Addendum No. 3
August 2, 2024

Project: Brandon Valley Elementary School
Brandon, South Dakota
Project #3023

Architect: Architecture Incorporated

11 FRAMING ELEVATION AT HIGH WIND SHELTER
3.44 NTS

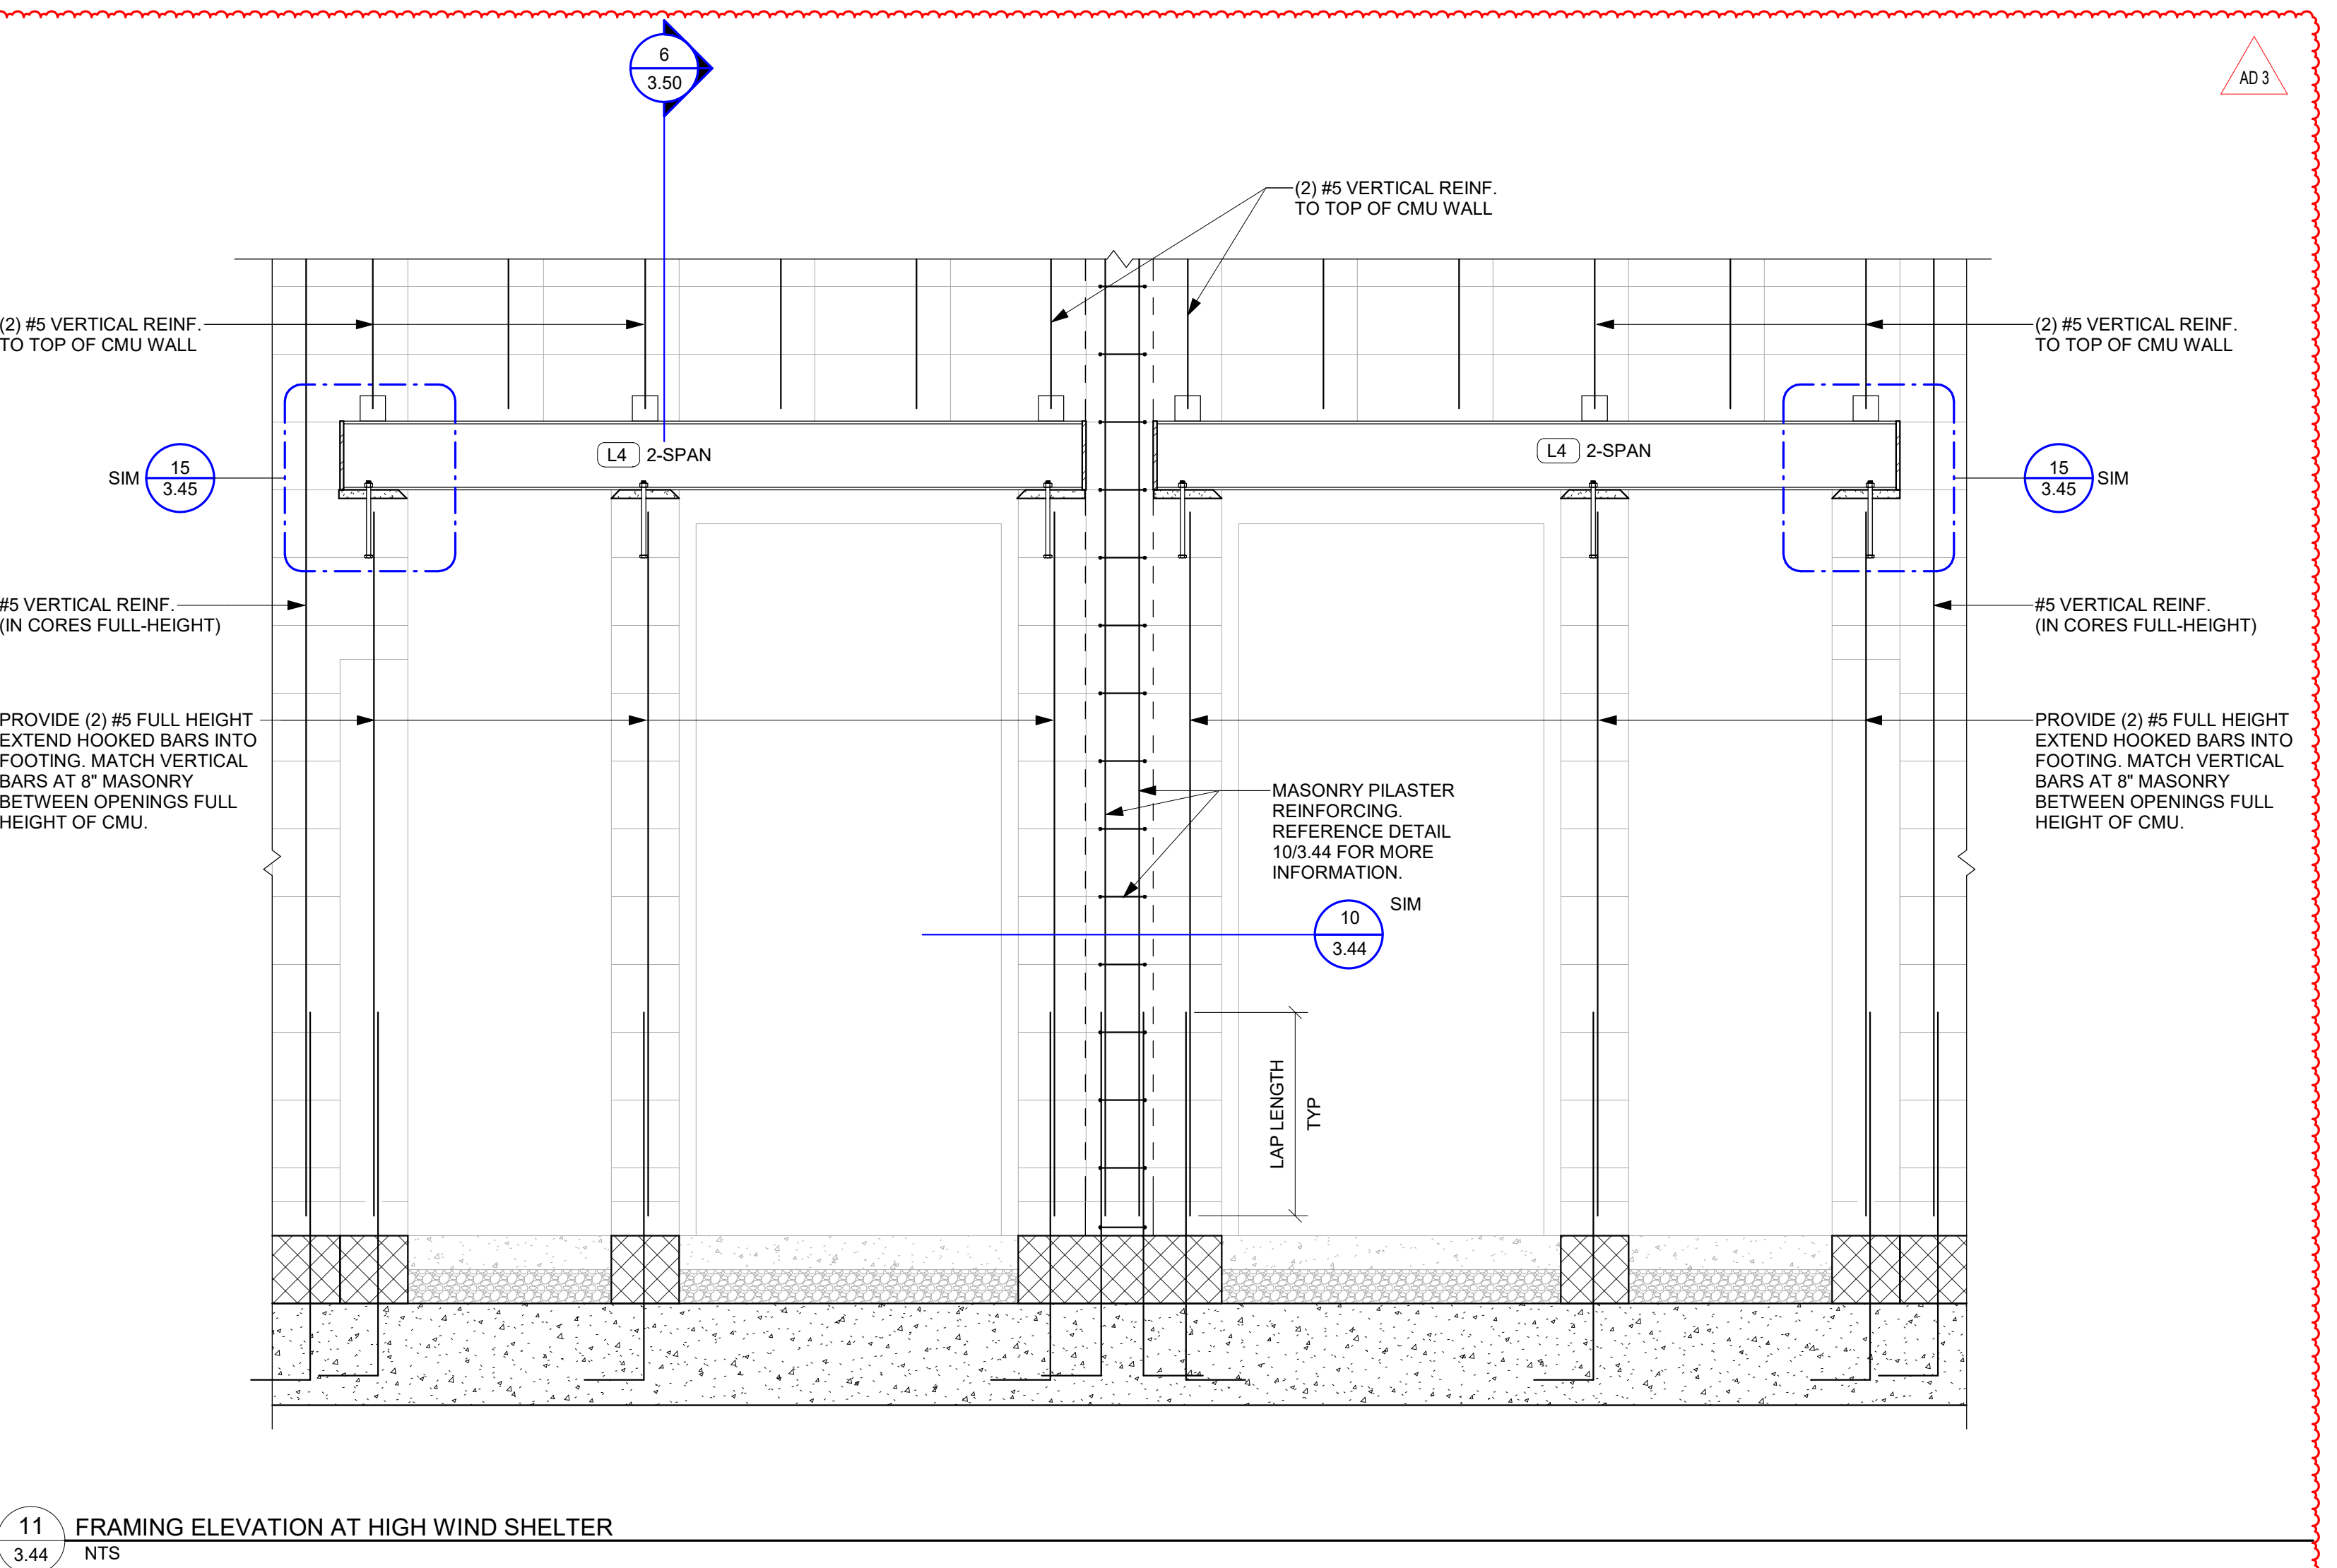
- iii) Reference New detail 11/3.44 for lintel framing elevation at high wind shelter openings.
- 16) SHEET 3.21 – ROOF FRAMING PLAN – AREA A
- a) Provide 8” masonry lintel bearing at door into Tray Room A120 as indicated in the revised Sheet 3.21, *revision* dated 8-1-2024, attached to the end of Addendum #3. *Note to precaster to provide embed plate for lintel connection was removed.*

- a) Add *NEW* details 10 and 11; reference *revised* Sheet 3.44, *revision* dated 8-1-2024 attached to the end of Addendum #3.

6 FRAMING SECTION
3.50 NTS

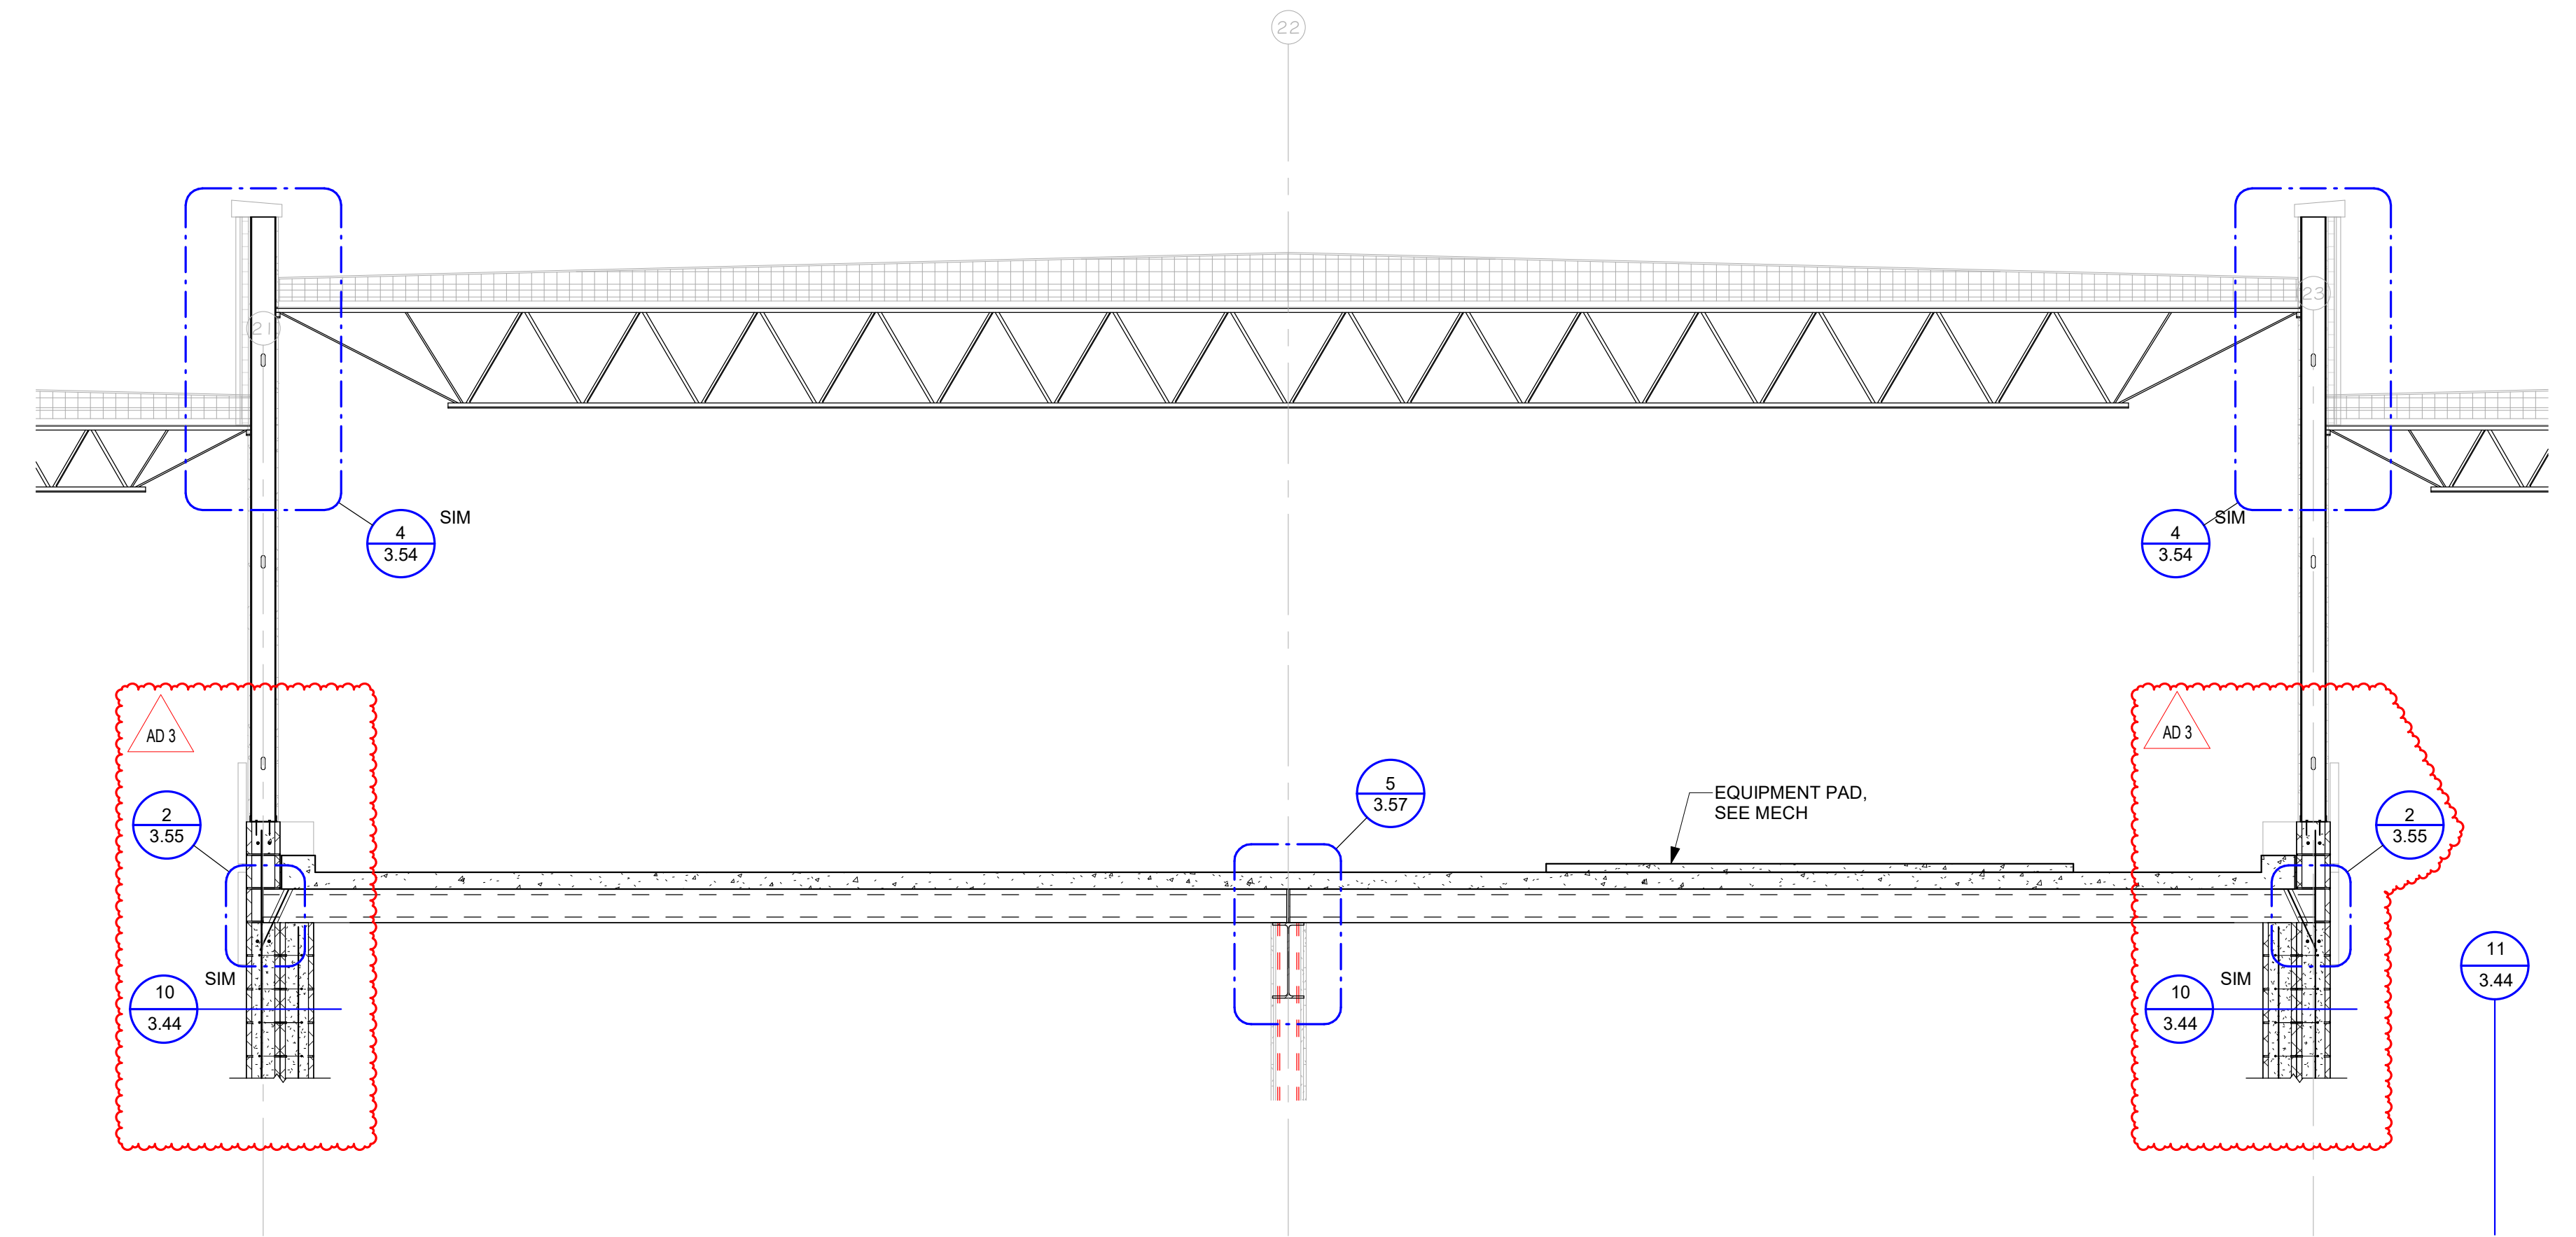
- a) Reference *revised* Sheet 3.50, *revision* dated 8-1-2024 attached to the end of Addendum #3 for the revised framing section 6/3.50.

FIRST FLOOR PLAN - AREA D

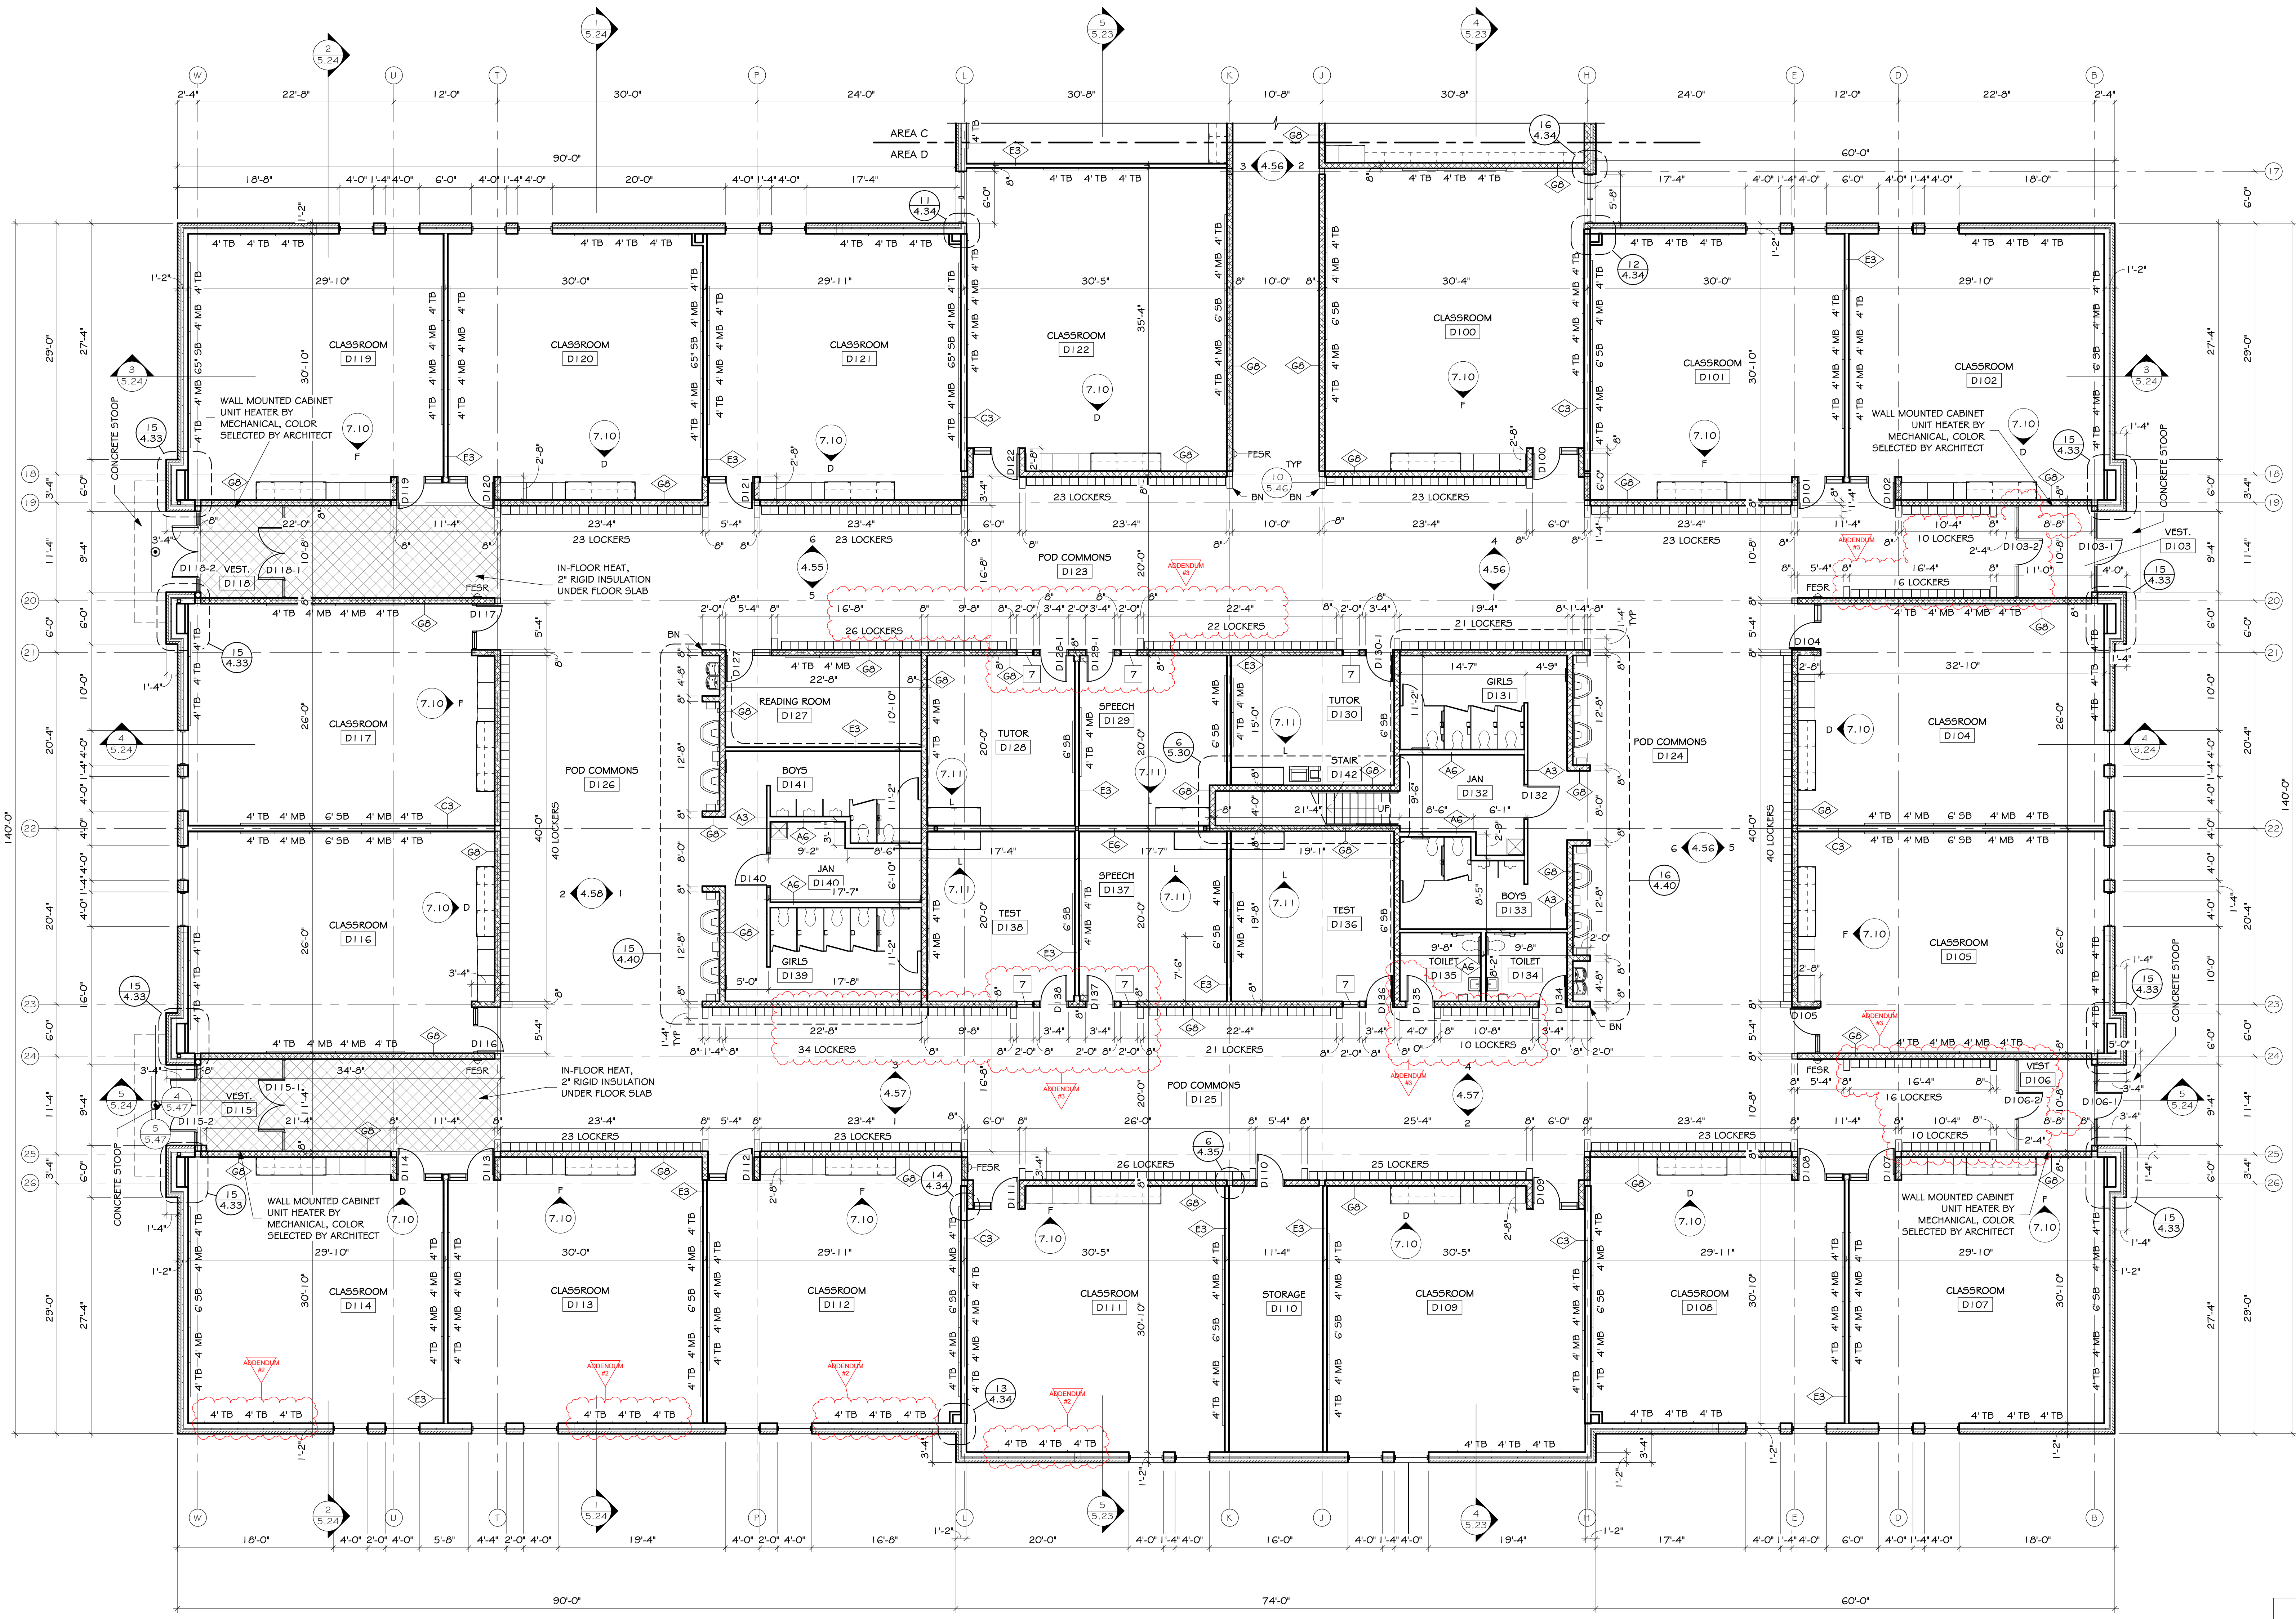
- i) Add a note to semi-recessed fire extinguisher located on the west wall of CORRIDOR B112 – as indicated.
- 28) SHEET 4.10D – FLOOR PLAN – AREA D
- a) Reference *revised* drawing Sheet 4.10D, *revision* dated 8-2-2024, attached to the end of Addendum #3 for the following modification:

- a) Detail 14/4.34 – Plan Detail – Area D Clarification: Extend 6” steel stud wall on grids H and L to steel tube column at doors D100, D109, D111, and D122 as shown on floor plan Sheet 4.10D.
